SUBJECT: Exhaust System Replacement

MODELS AFFECTED: M20A, S/N 1201-1700  
M20B, S/N 1701-1851, 1853-1939  
M20C, S/N 1852, 1940-3466, 670001, 670002,  
670005-670020, 670022-670027,  
670029-670031, 670042, 670051  
M20D, S/N 1, 101-260  
M20E, S/N 101-1308, 670001  
M20F, S/N 670001-670245, 670247-670257  
670259-670342

SERVICE BULLETIN KIT NO. M20-152:

FIGURE 1

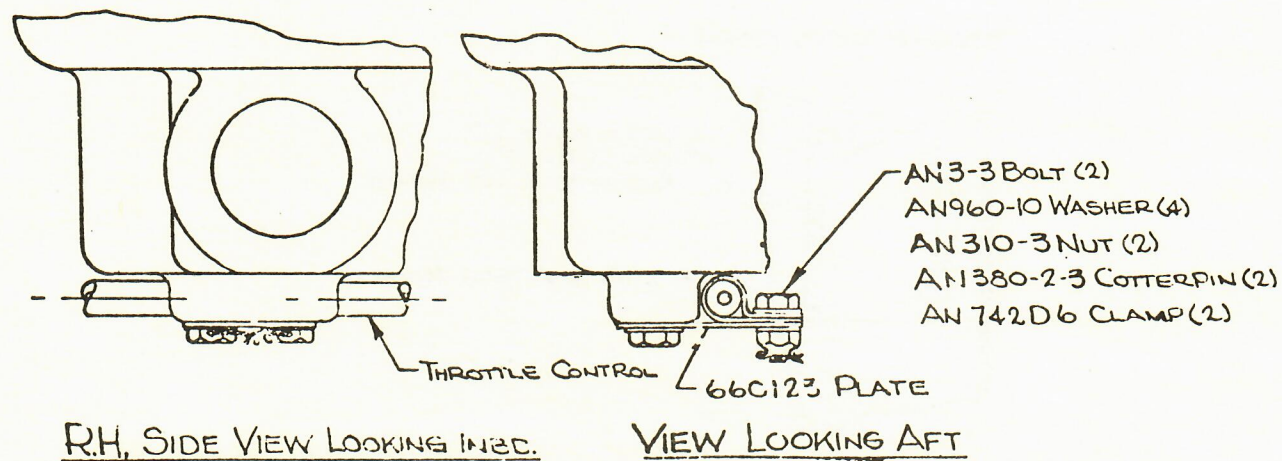
1. Remove both side and bottom cowling.
2. Disconnect all heating ducts at the muffler.
3. Remove exhaust system and tail pipe hanger.
4. Comply with Service Bulletin M20-144
5. Install the M20-152-601 exhaust system with hardware furnished.
6. Secure the tail pipe to the hanger.
7. Install the ducts to the muffler.
8. Rework the right hand cowl flap per Figure 1.
9. Install all cowling previously removed.

RIGHT HAND COWL FLAP LOOKING DOWN

FIGURE 2

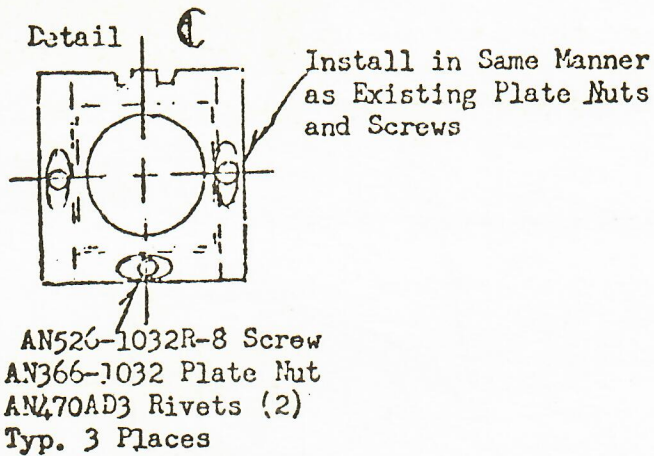
1. Remove both side and bottom cowling.
2. Disconnect all heating ducts at the muffler.
3. Remove exhaust system and tail pipe hanger.
4. Comply with Service Bulletin No. M20-144.
5. Install the M20-152-603 exhaust system with hardware furnished.
6. Secure the tail pipe to the hanger.
7. Install the ducts to the muffler.
8. Replace the right hand cowl flap with 650015-507.
9. Replace the oil cooler air deflector bottom inboard spacer part no. 914022-5 with 914022-27 furnished.
10. Remove the 620014 oil line shield located on the bottom . LH outboard cowl rail. Replace with 620014 furnished. Installed on the outboard side of the cowl rail attaching with AN426AD4 rivets. Secure the 620014 shield to the bottom side of the AN743-12 clip with the existing hardware.
11. Install throttle bracket P/N 660123 furnished per Figure No. 2.
12. Install all cowling previously removed.

8. Replace the right hand cowl flap with 650015-507 furnished.
9. Replace the oil cooler air deflector bottom inboard spacer part no. 914022-5 with 914022-27 furnished.
10. Remove the 620014 oil line shield located on the bottom L.H. outboard cowl rail. Replace with 620014 furnished, install on the outboard side of the cowl rail attaching with AN426AD4 rivets. Secure the 620014 shield to the bottom side of the AN743-12 clip with the existing hardware.
11. Install the throttle bracket part no. 660123 furnished per Figure #2.
12. Replace all cowlings previously removed.
